City of Visalia
Building: Site Plan
Review Comments

ITEM NO: 7 DATE: March 26, 2014
SITE PLAN NO: SPR13198 **RESUBMIT**
PROJECT TITLE: BUSINESS RESEARCH PARK
DESCRIPTION: BUSINESS RESEARCH PARK ON 25 ACRES WITH
MASTER PLAN, CONDITIONAL USE PERMIT AND
PARCEL MAP (BRP ZONED) (DISTRICT G)
APPLICANT: ROYE MICHAEL
PROP OWNER: ROYE LINDA
LOCATION: 224 S NEELEY ST
APN(S): 081-170-001 081-170-002 081-170-003 081-170-009
081-170-010 081-170-014

SITE PLAN NO.: 13-198 2ND RESUBMITTAL
PROJECT TITLE: BUSINESS RESEARCH PARK
DESCRIPTION: BUSINESS RESEARCH PARK ON 25 ACRES WITH MASTER PLAN, CONDITIONAL USE PERMIT AND PARCEL MAP (BRP ZONED) (DISTRICT G)

FIGURE D103.1
DEAD-END FIRE APPARATUS ACCESS ROAD TURNAROUND

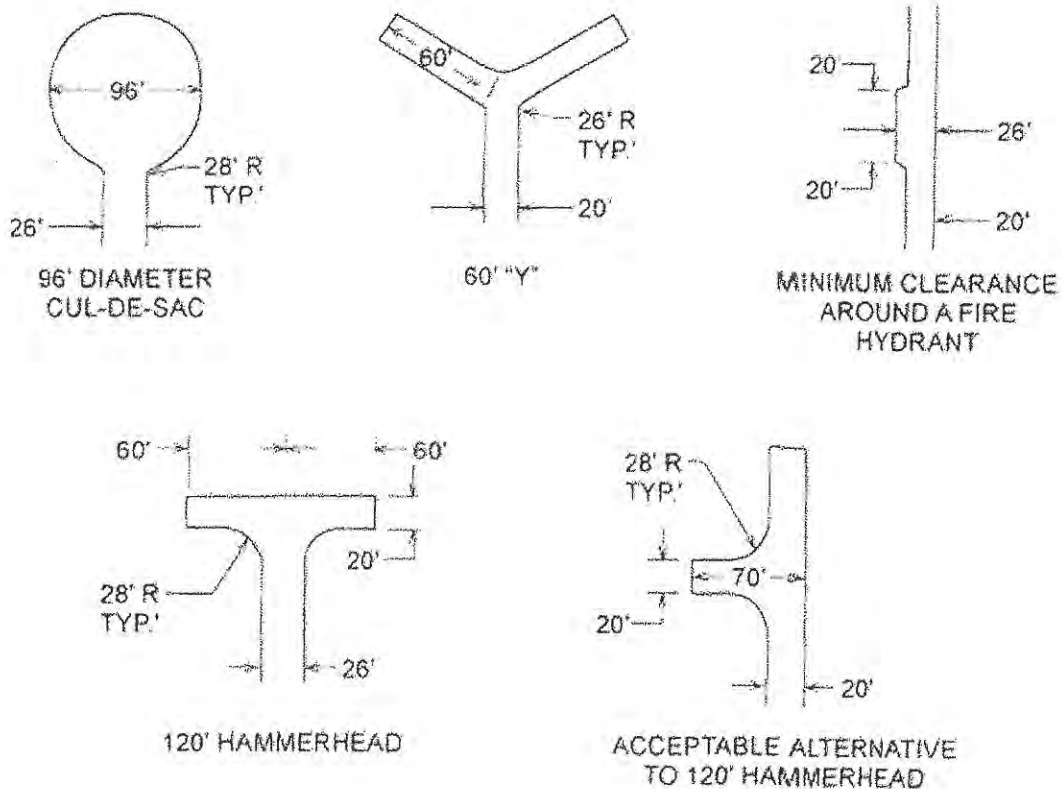
- Fire apparatus access roads in excess of 150 feet and dead end shall be provided with a turnaround. Length 151-500 feet shall be a minimum of 20 feet in width and have a 120 foot Hammerhead, 60-foot "Y" or 96-Foot diameter Cul-de-sac in accordance with Figure D103.1 of the 2013 CFC. Length 501-750 feet shall be 26 feet in width and have a 120 foot Hammerhead, 60-foot "Y" or 96-Foot diameter Cul-de-sac in accordance with Figure D103.1 of the 2013 CFC.
